OREGON PARKS & RECREATION DEPARTMENT  
5330 Seaman Road  
Oregon, Ohio 43616  
(419) 698-7145  
FAX (419) 698-7086

**ADDENDUM No. 1**  
**Recreation Buildings - 2023**

Plan holders of the Recreation Buildings - 2023 Project are hereby notified of the following amendments to the Contract Documents. The following additions, alterations, deletions and/or clarifications shall be part of the bid specifications as much as if they were originally included in the Contract Documents. This Addendum No. 1 is hereby made a part of the Contract Documents and must be receipted for on the proposal form.

### A5.3

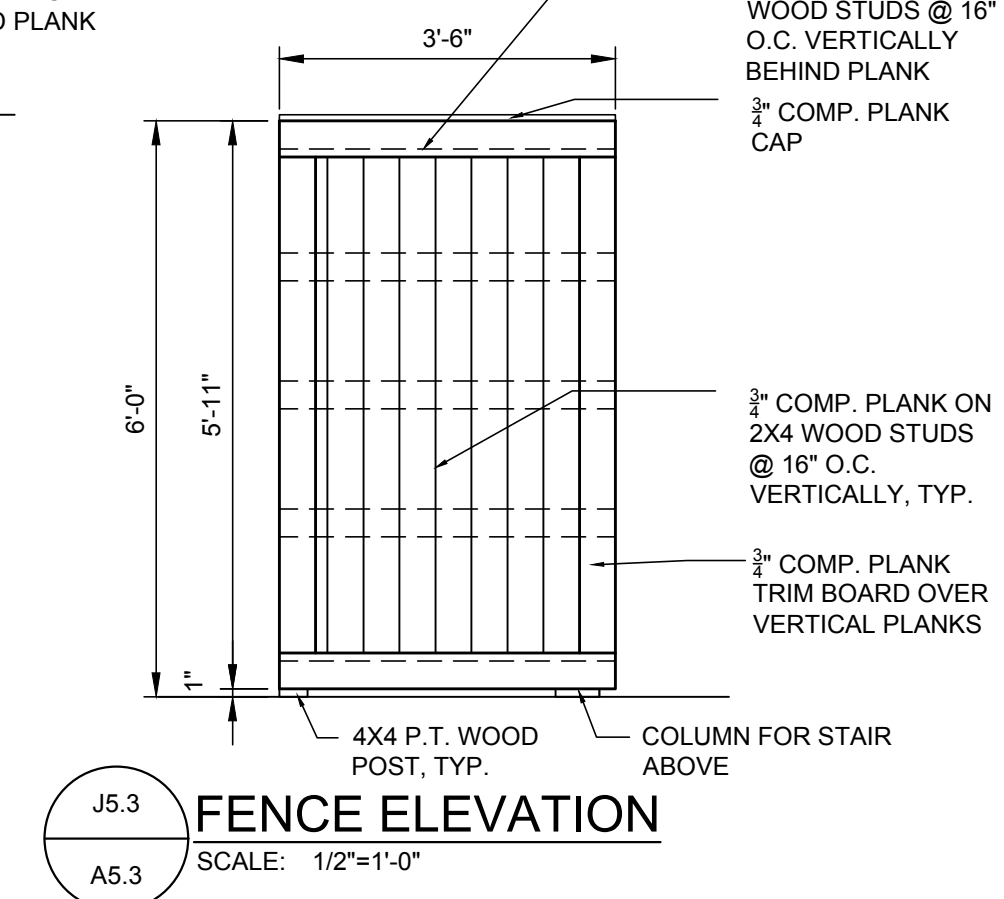
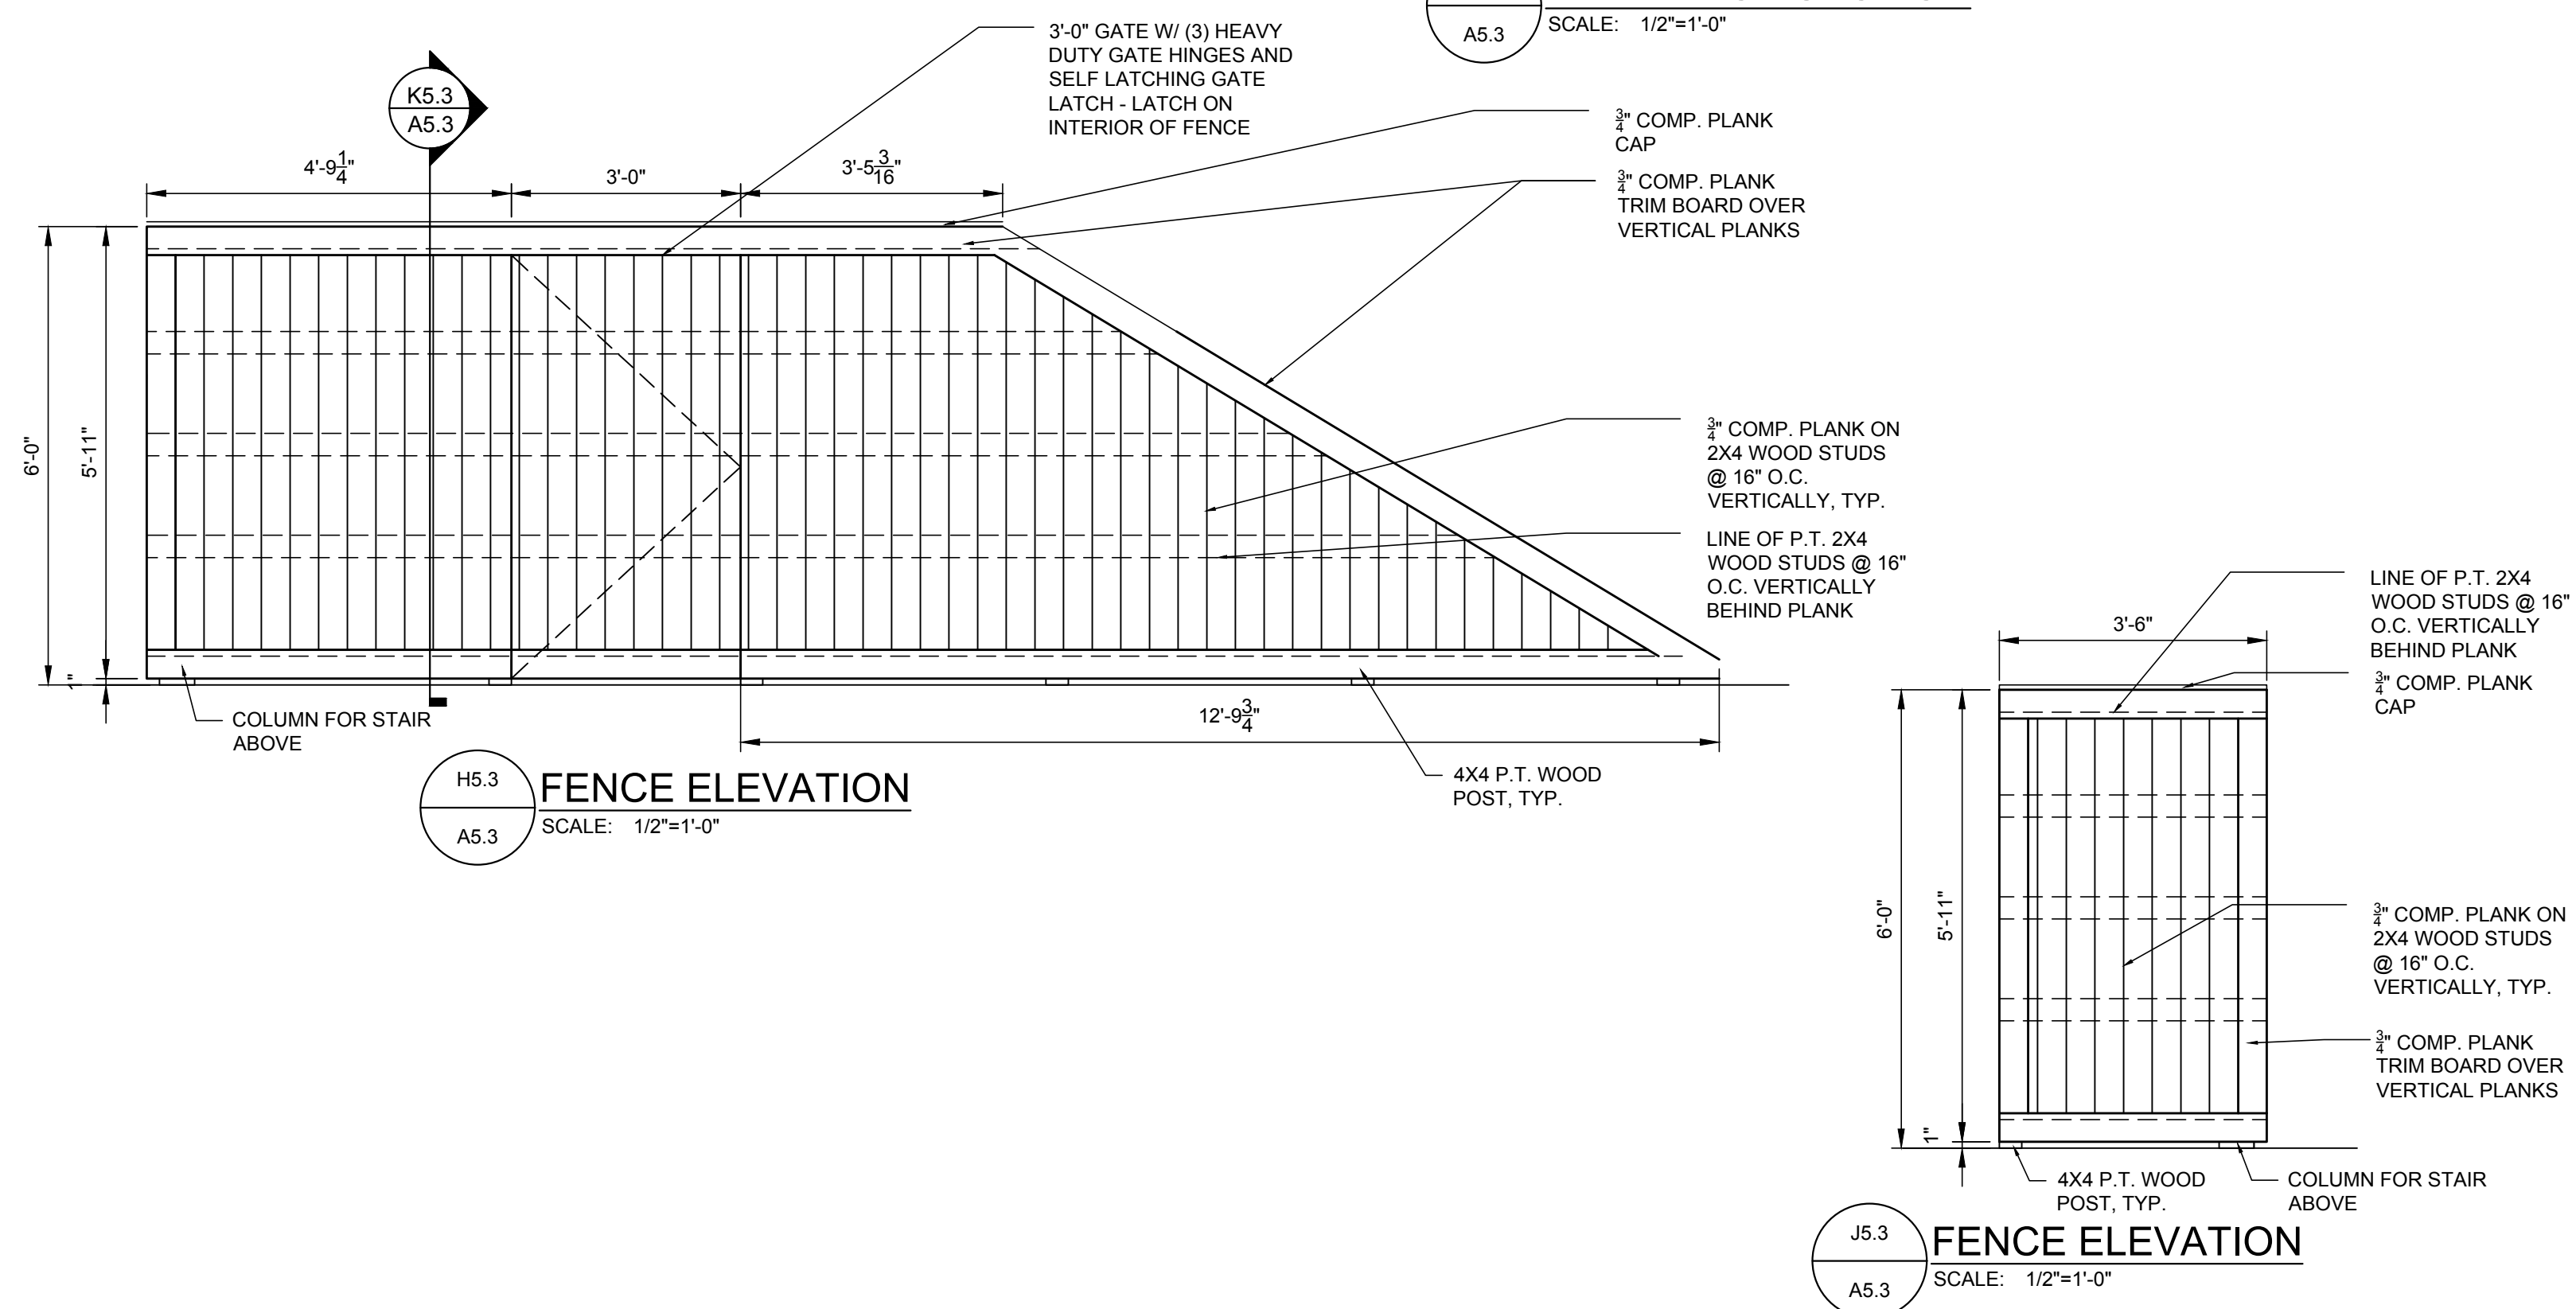
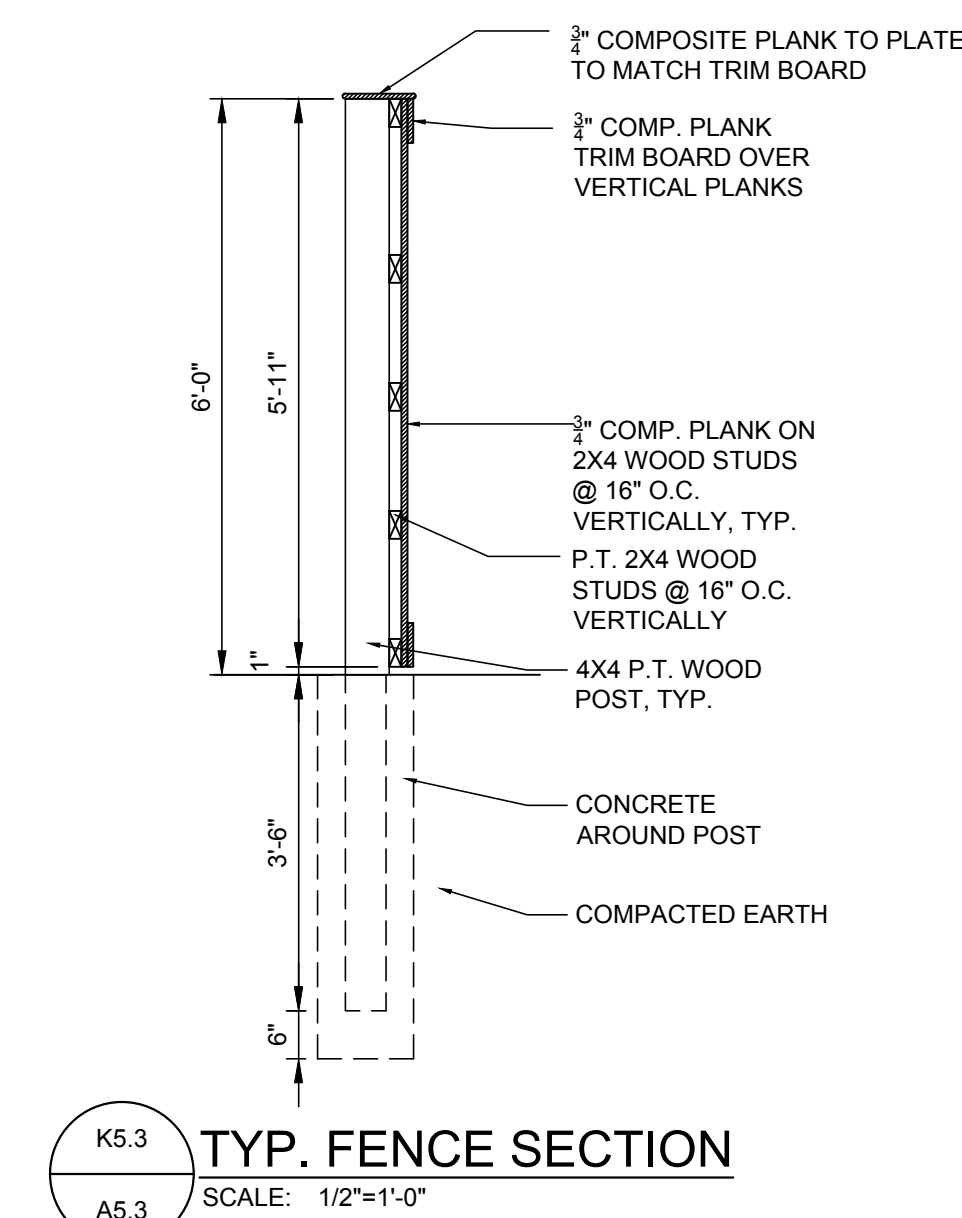
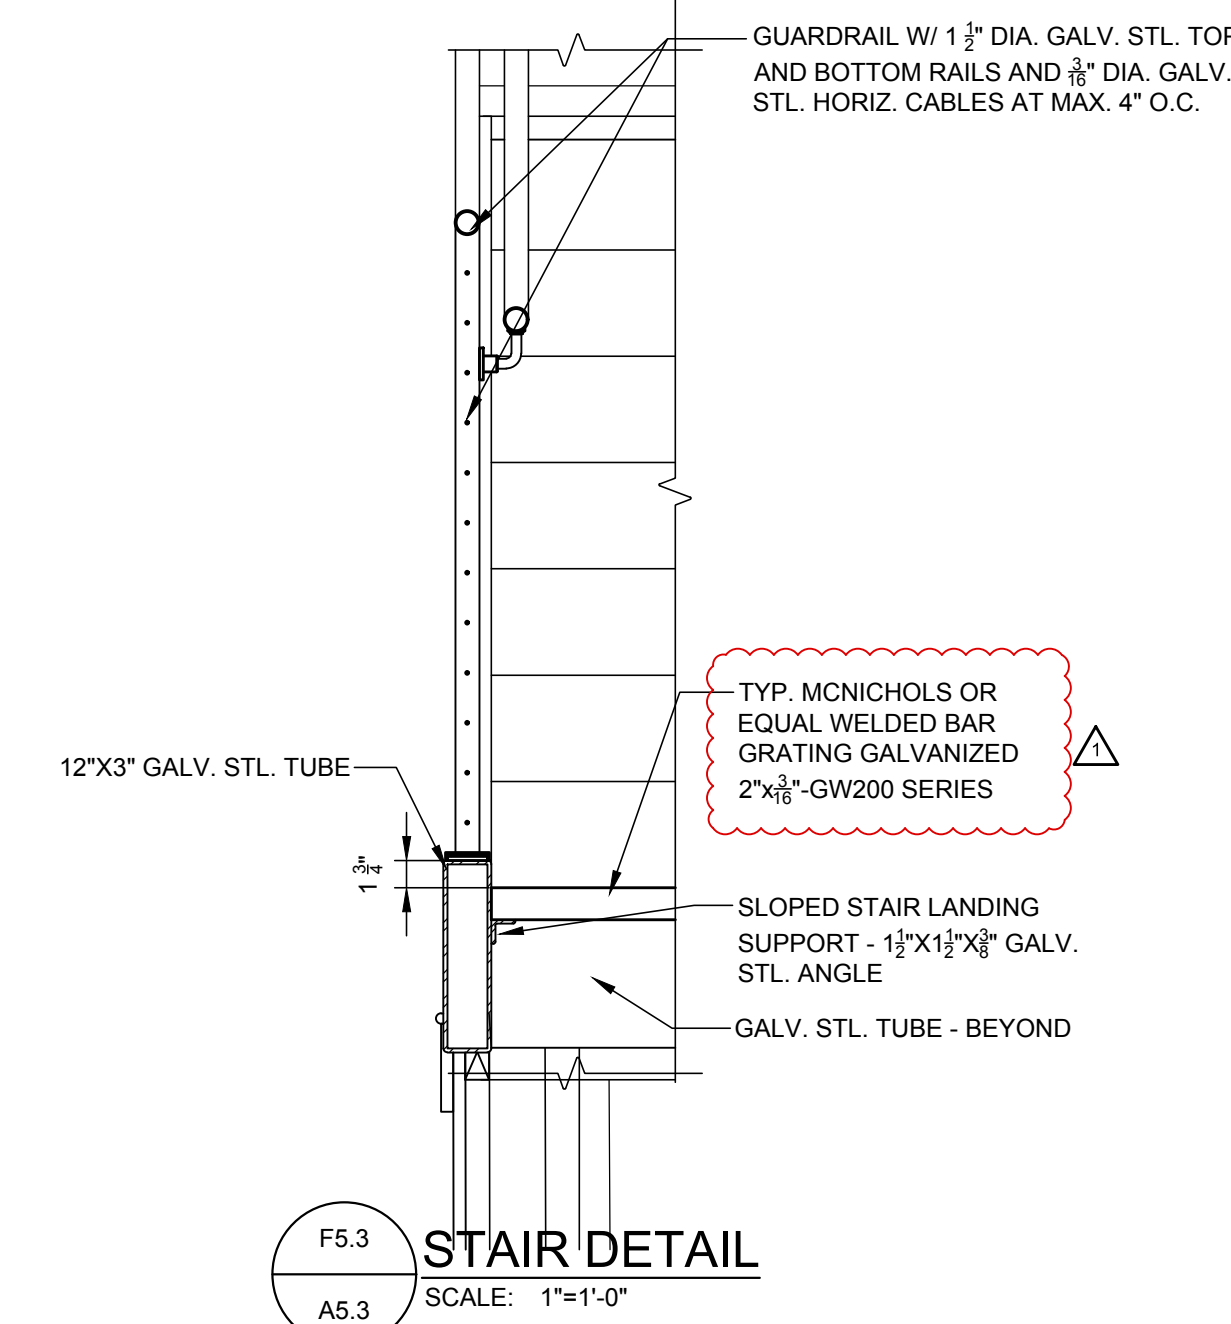
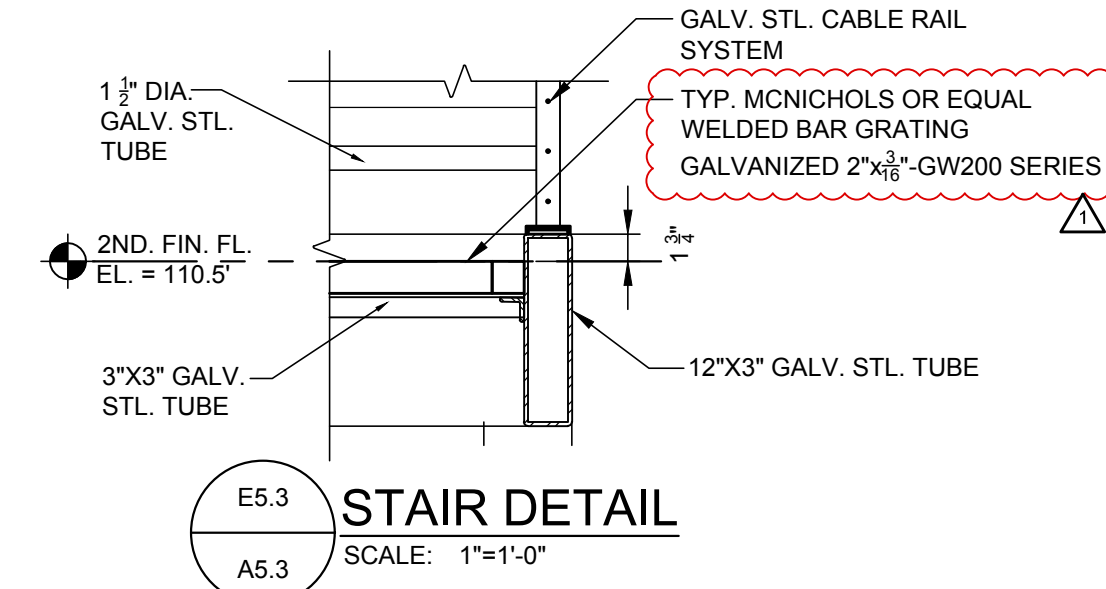
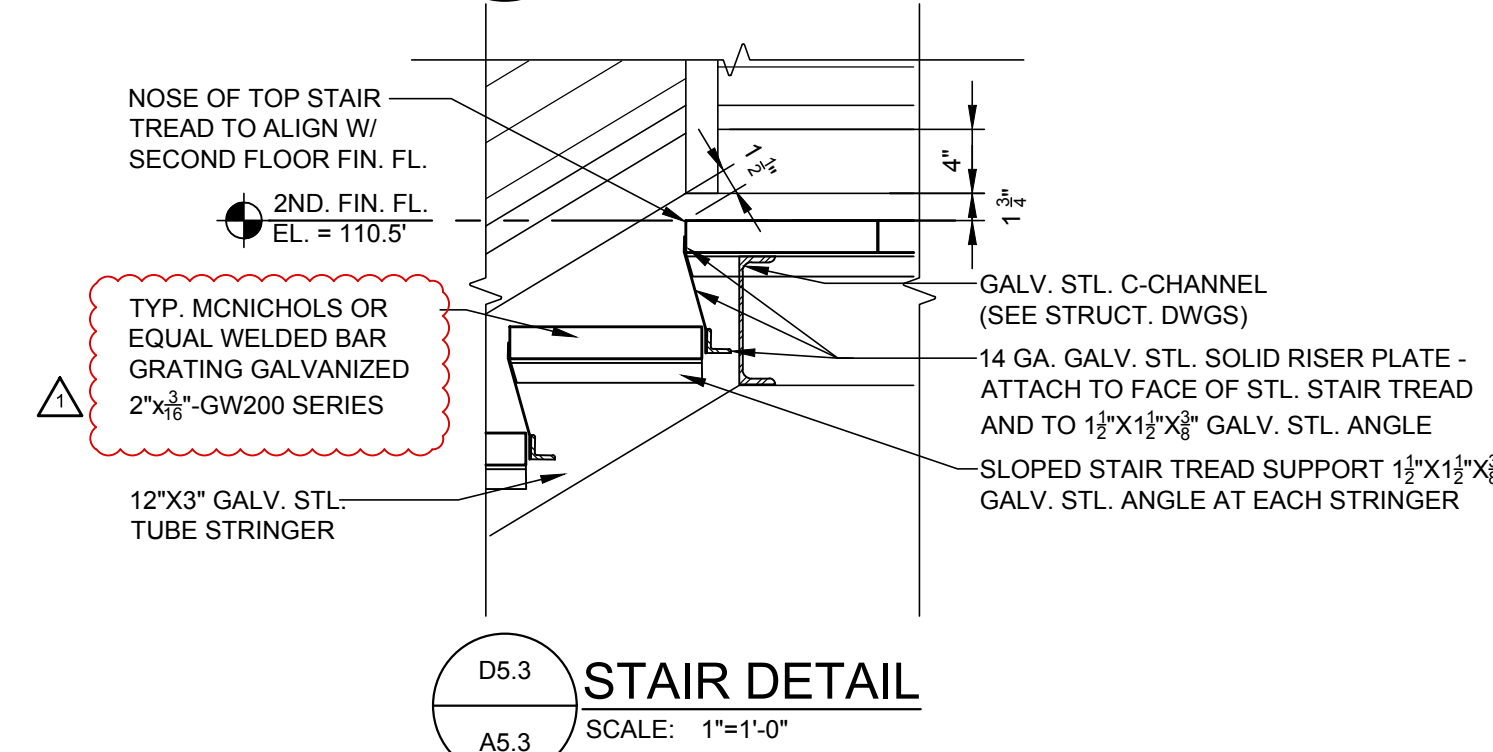
- 13) **Bidder Question:** *Regarding the stairs to the Pressbox: Drawing S2.2 calls for Welded Bar Grating as the walking surface, A5.3 calls for traction treads. Please confirm which is correct.*

- 14) **Bidder Question:** *Please provide additional details on the cable railing?*

**Architect/Engineer Response:** Welded bar grating is correct. Drawing A5.3 was corrected to match S2.2.

**Architect/Engineer Response:** New cable railing specification was added. Railing details can be found on sheet A5.3.
